ARC REVIEW CODE: R2110211

TO: Chairwoman Nicole Hendrickson  
ATTN TO: Catherine Long, Long Range Planning Manager  
FROM: Douglas R. Hooker, Executive Director  
RE: Development of Regional Impact (DRI) Review

**Name of Proposal:** 6405 Sugarloaf Parkway DRI 3468

**Description:** A Development of Regional Impact (DRI) review of a proposal to build a mixed-use development on a 40.45-acre site at 6405 Sugarloaf Parkway in unincorporated Gwinnett County. The site is bounded by Sugarloaf Pkwy. on the west and Satellite Boulevard on the east. The proposed development plan includes 585 multifamily units, 122 townhomes, and 4,000 SF of retail space. Site access is proposed via an existing full movement driveway at the signalized intersection of Sugarloaf Pkwy and the Gas South District driveway, as well as a new right-in/right-out only driveway on Sugarloaf Pkwy. A potential third driveway is being contemplated on Satellite Blvd. at the existing signalized intersection with the Residence Inn/Courtyard by Marriott driveway. The nearest transit access is Gwinnett County Transit route #10B, with a stop on Satellite Blvd., just south of Sugarloaf Pkwy. The nearest state routes are I-85, a

DRI SITE PLAN

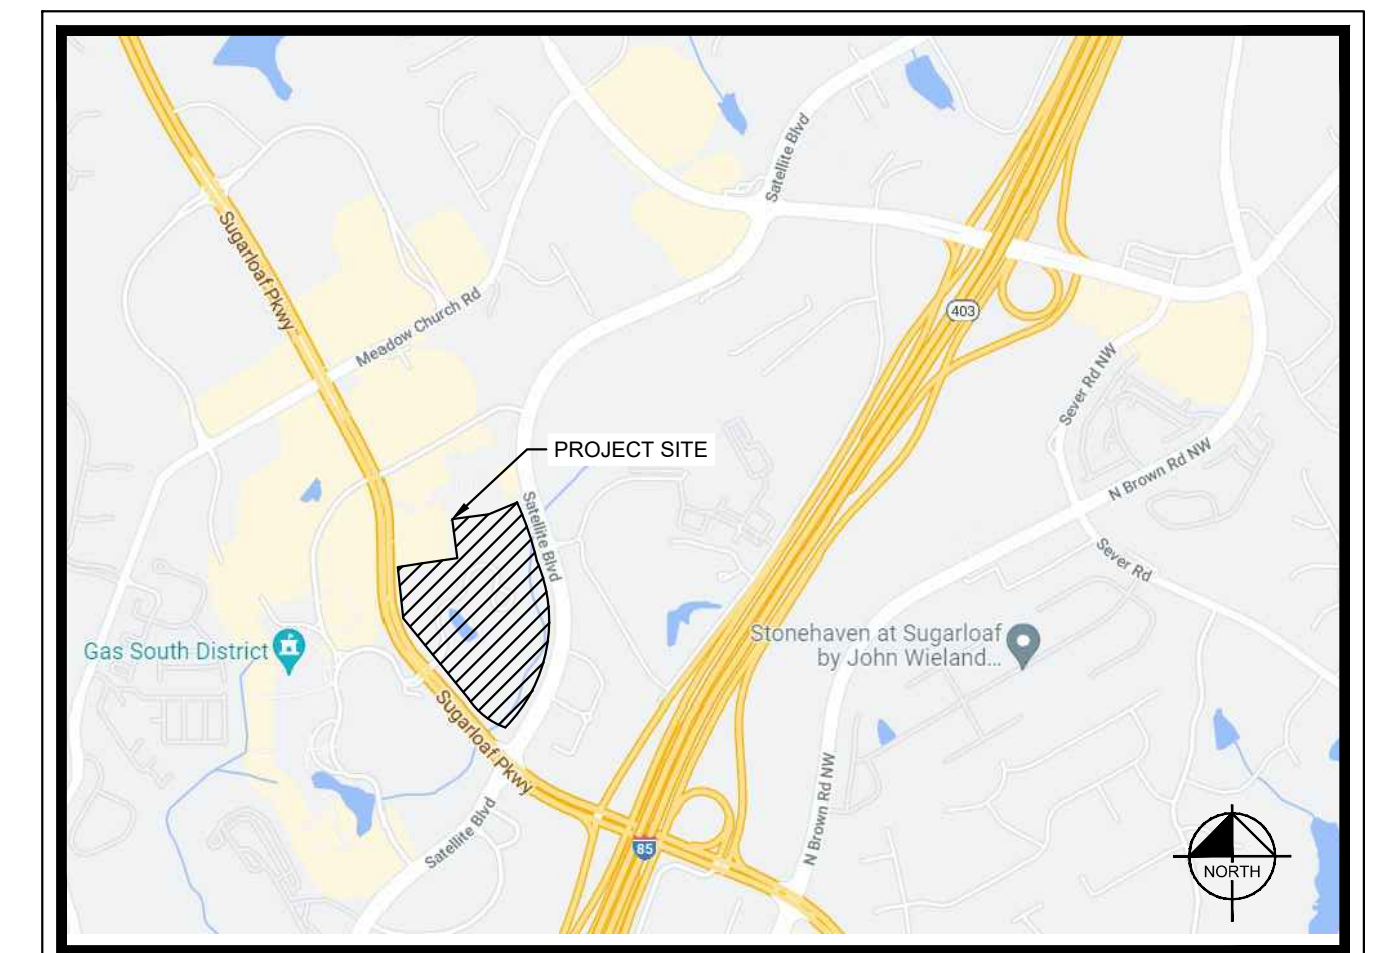
The project proposes a combination of twenty townhome buildings and six four-to five story multi-family buildings. Nine of the townhome buildings are sited along Sugarloaf Parkway which will help create more of a sense of place and appealing frontage along the street and can also help slow traffic and encourage pedestrian activity. These positive urban form effects could be significantly furthered by shifting one or more of the larger multi-family buildings from the center of the site to the Sugarloaf Parkway frontage. The larger buildings would have a major placemaking effect if they directly fronted the roadway. This would also provide additional walkability. The parallel shifting some of the townhomes from the proposed frontage location into the more central portion of the site could allow for the retention of additional tree canopy, which could enhance the overall value of the development and provide other benefits.

Comments from ARC's Natural Resources Group are attached. Both the site plan and the USGS coverage for the project area show a perennial blue-line stream and an intermittent tributary on the property. The

perennial stream runs along the eastern and southeastern portions of the property, roughly paralleling Satellite Boulevard. The intermittent stream runs north-south just west of the center of the property, joining the perennial stream near the southern end of the parcel. Buffers that appear to be the Gwinnett County Stream Buffer Ordinance 50-foot undisturbed buffer and 75-foot impervious surface setback, as well as the State 25-foot Sediment and Erosion Control buffer are shown on the submitted site plan but are not identified. No intrusions into the buffers along the perennial stream are shown, except for a proposed driveway connection, which, as a transportation crossing, is allowed under the Gwinnett buffer ordinance. Proposed grading shown along the intermittent stream extends into the 75-foot setback and may require a variance under the Gwinnett ordinance.

Although the number of parking spaces is being limited to close to the minimum required which is also to be commended, there is still a very large area of surface parking proposed. As mentioned earlier, the possibility of further reduction of parking spaces is worth considering as there are or will be substantial alternative transportation options available. This would reduce the large amount of impervious area proposed. The project can further support regional planning goals in this area by incorporating aspects of regional policy, including green infrastructure and/or low-impact design, e.g., pervious pavers, rain gardens, vegetated swales, etc., throughout the site in general – especially in parking areas, on site driveways, and as part of any improvements to site frontages.
